**SOLID WASTE APPROVAL**

**CS-101**

Isaacson & Arfman, Inc.

**DERMATOLO**

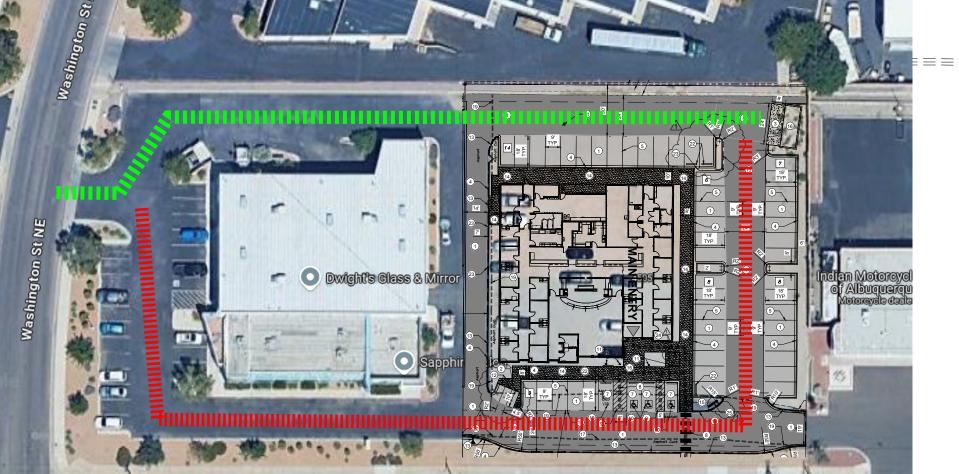
Approved for access by the Solid Waste Department.

All containers must be made accessible for pick up

between the hours of 5AM and 8PM.

\*\*In the event that the property owner of the parcel to the west does not permit access to the trash enclosure via their property, the refuse collection service will be rerouted as a hazardous access route. As a result, the cost of the refuse service will increase.\*\*
